36 FT. LC.V.P.
RELOCATION AND REVISION-
BILGE PIPING SYSTEM

CODE 452 BUREAU OF SHIPS: 17 JAN 1957
W.H.H.

BUSHIPS SKETCH NO 027159
REVISION N-1

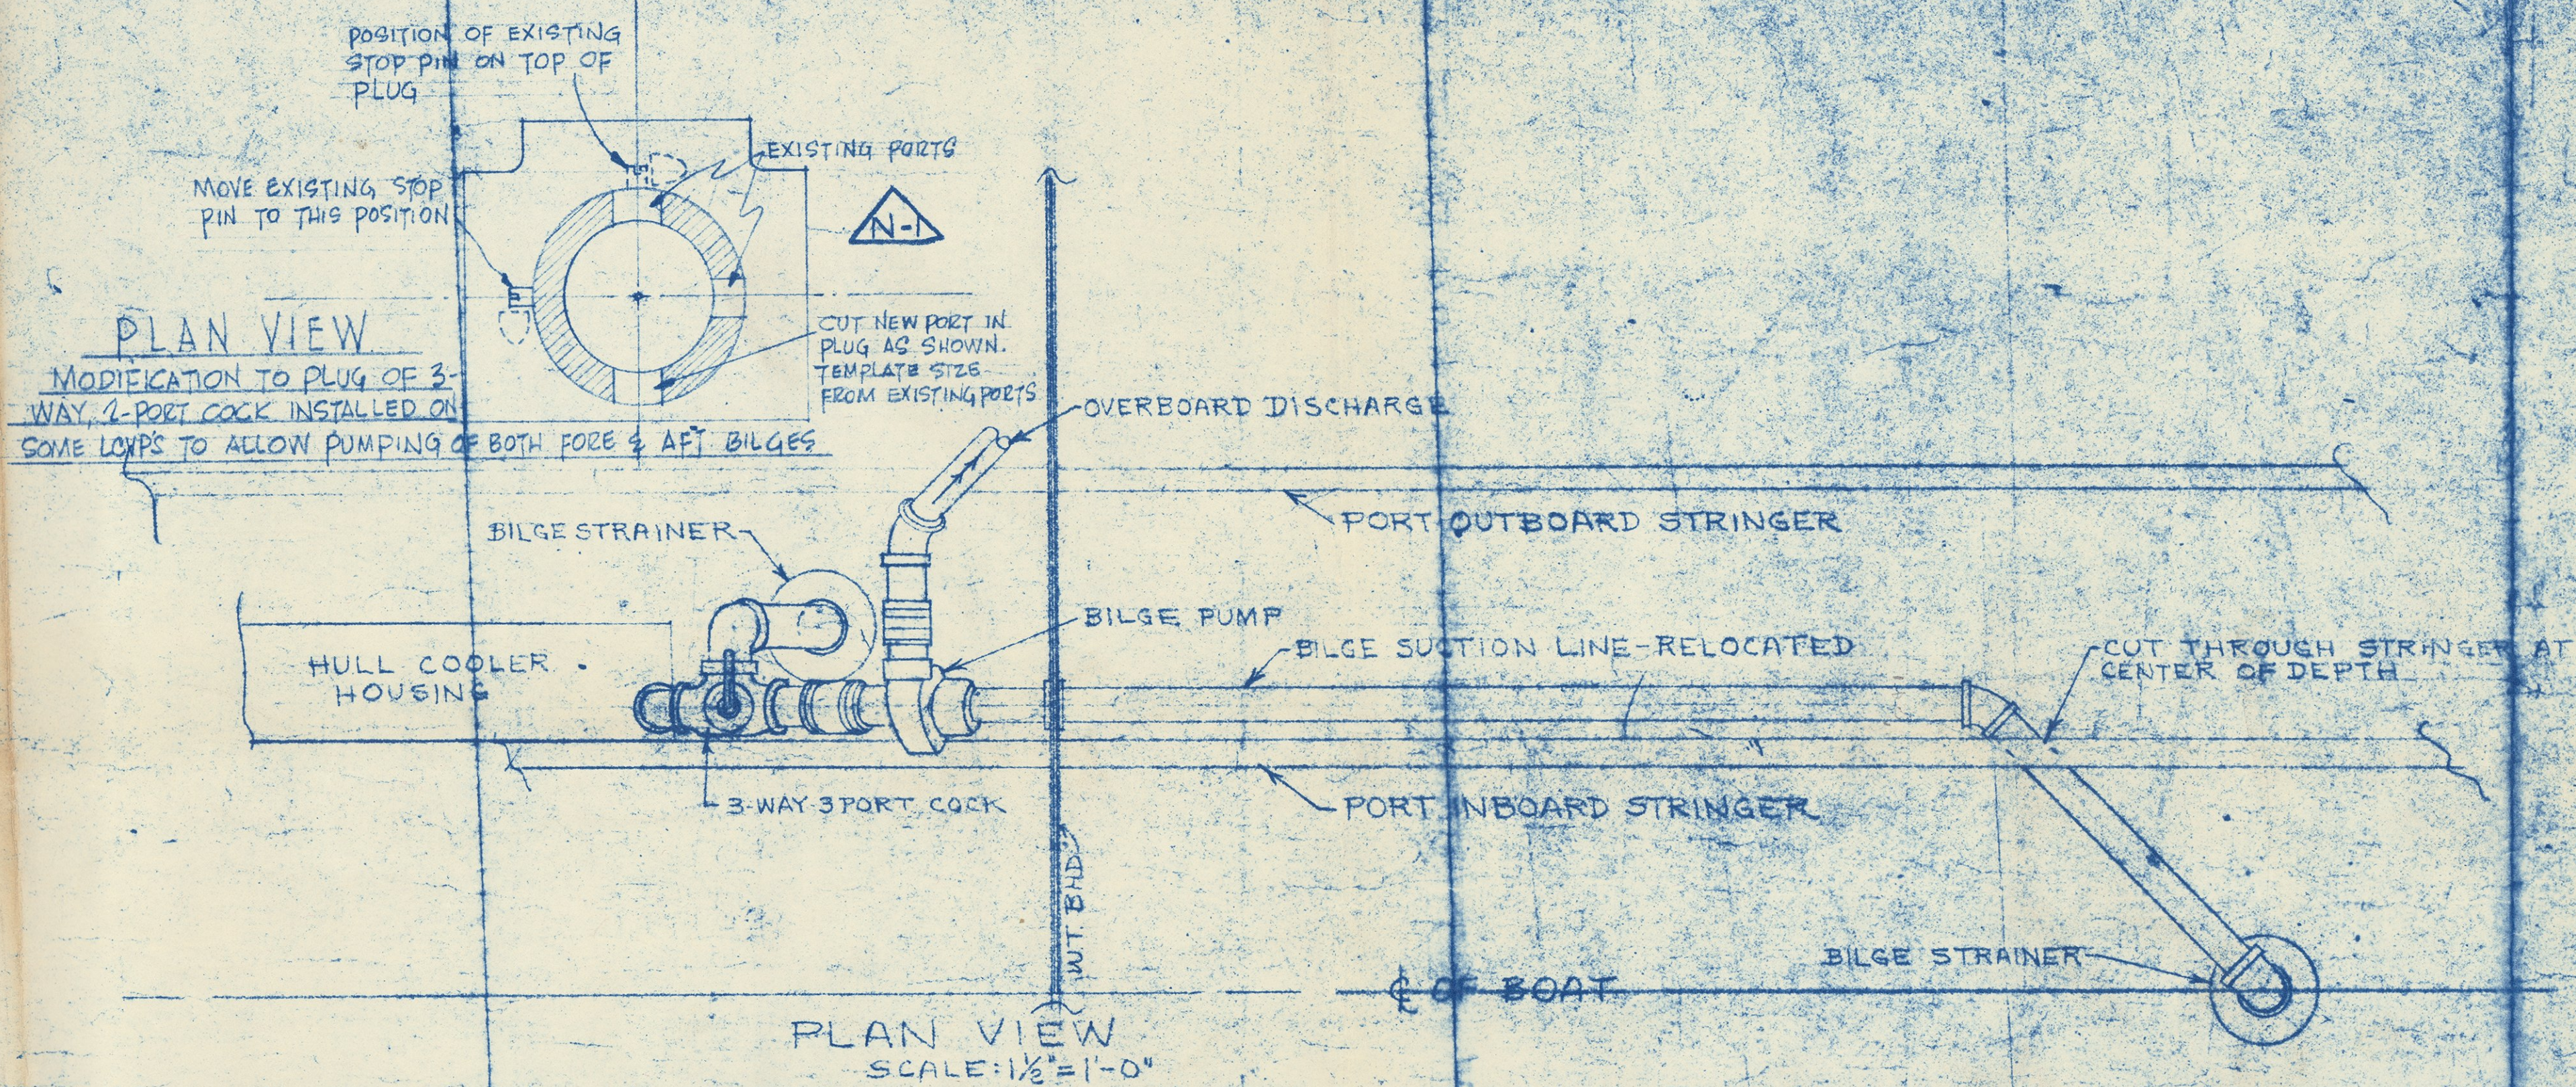
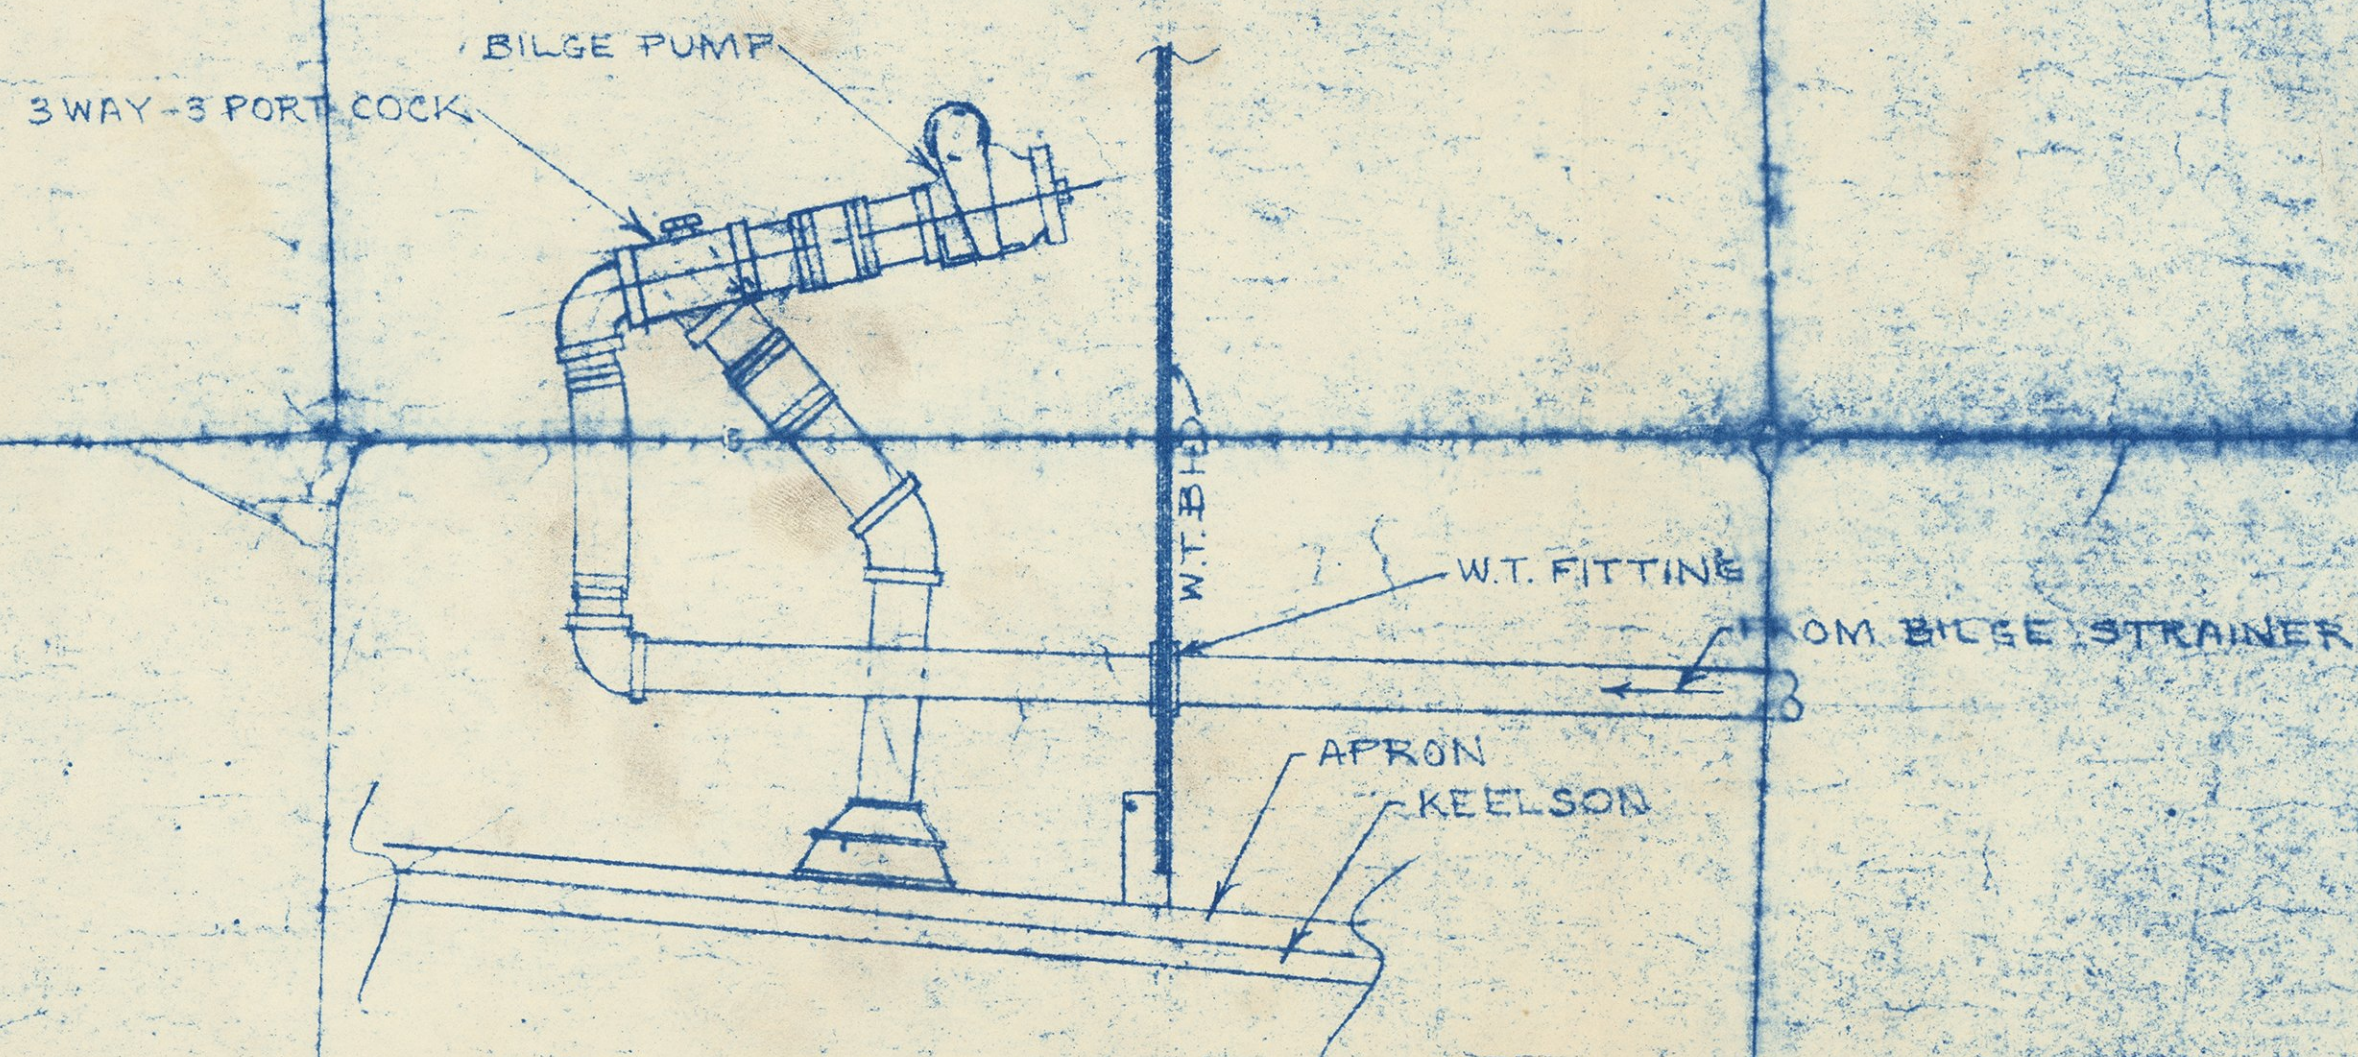
REV.	DESCRIPTION	APPD.	DATE
N-1	ADDED NOTE 3 AND DETAIL OF MODIFICATION TO PLUG COCK IN BILGE SUCTION	W.H.H.	12/30/57

- NOTES
1. ALL PIPING AND FITTINGS PRESENTLY IN BOAT CAN BE REUSED WITH THIS ARRANGEMENT BY SUBSTITUTING ONE 45° ELL FOR ONE 90° ELL.
 2. RUBBER HOSE AND CLAMPS TO BE INSTALLED AS REQUIRED FOR EASE OF DISASSEMBLY.
 3. 3-WAY 2-PORT PLUG COCK INSTALLED ON SOME "LCVP'S" MUST BE MODIFIED AS SHOWN IN DETAIL TO ALLOW PUMPING FORE AND AFT BILGES.
